C & R Sweater Limited

21st January & 13th February 2020

Observations

Water ponding on roof slab at Building-1

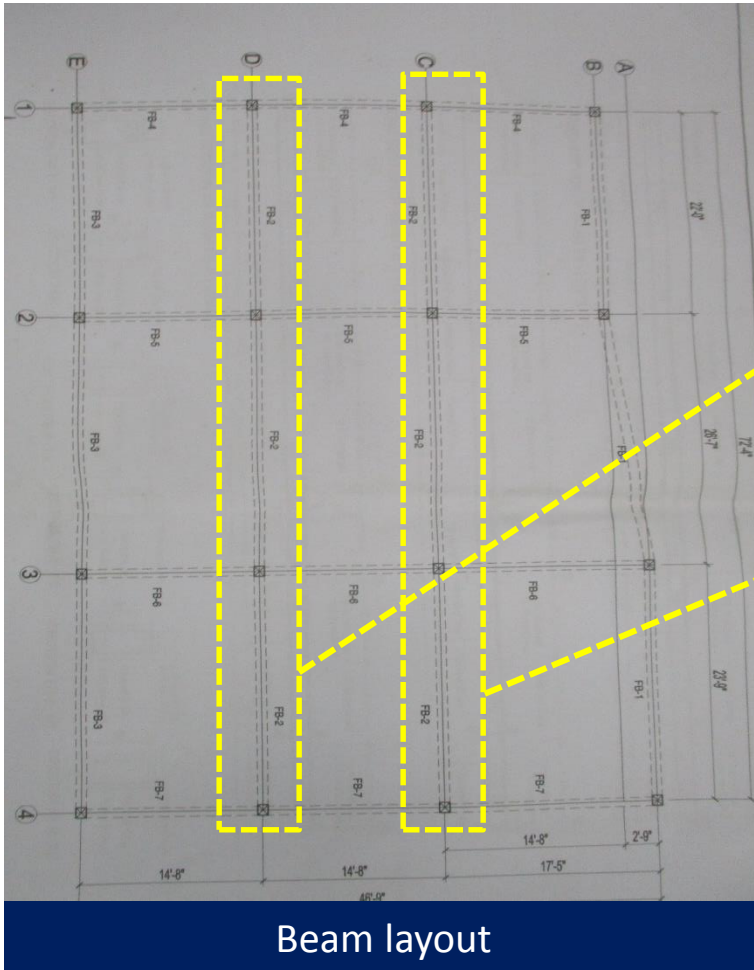
Water ponding was found at roof of Building-1. During inspection sign of water ponding was found. Factory is required to provide water proofing layer and improve drainage system to avoid water ponding.

Beam layout

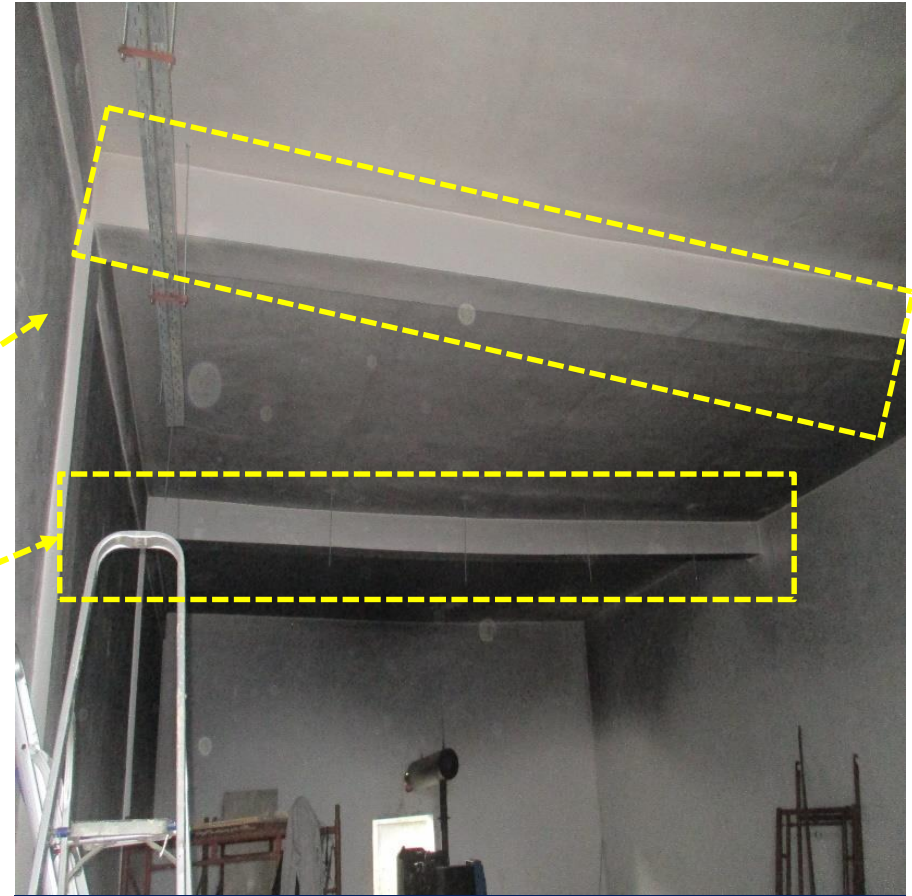
Length of Span in longitudinal direction is 9.7m but beam size is 250mm (W)X 315mm (d/s) which appeared to be undersized. Beam were also found sagged. Factory engineer is required to carry out the adequacy check of all beams.

Rafter Layout

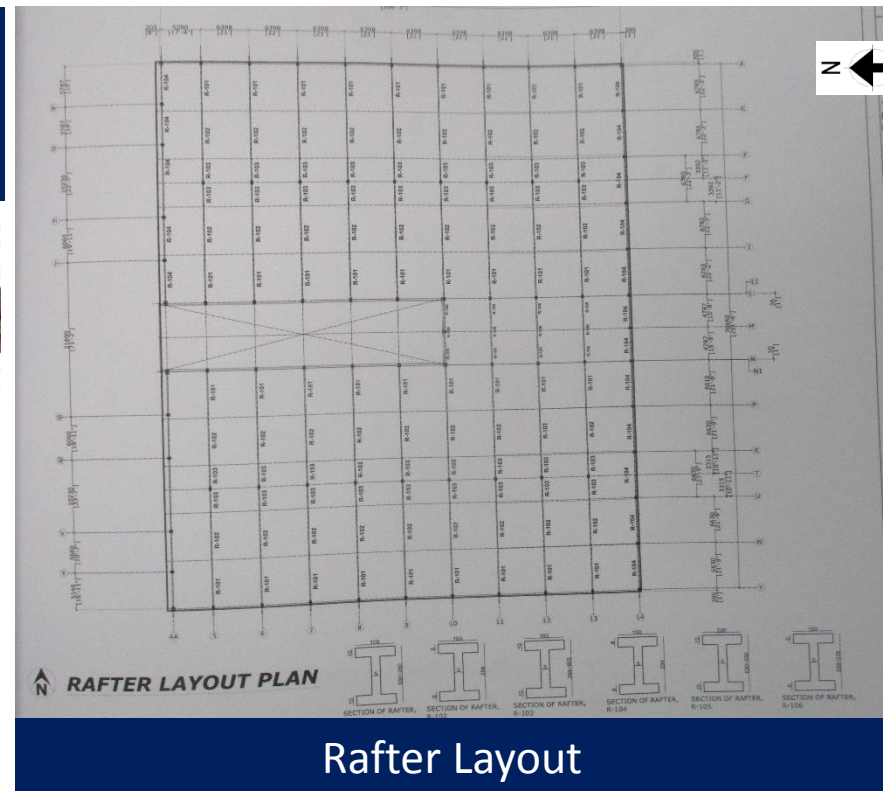
Flange thickness of end rafter was found 7 mm instead of 8 mm. Also, Connection details were not shown in drawing.

Missing vertical bracing

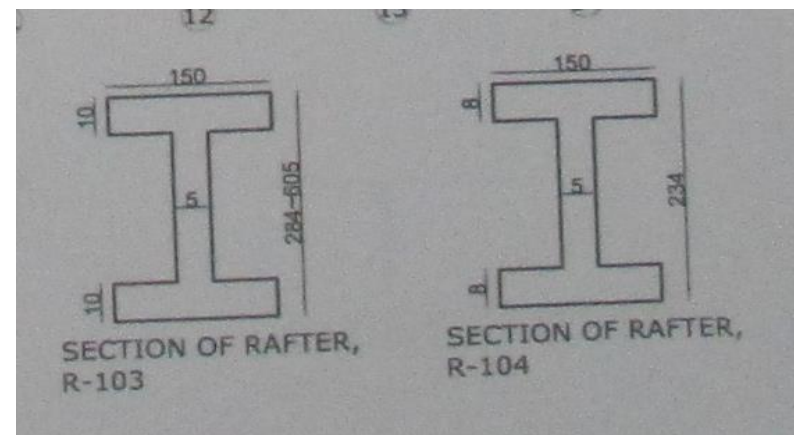
Vertical bracings are missing at all location which are shown in drawing. Also horizontal roof cable bracings were found loose.
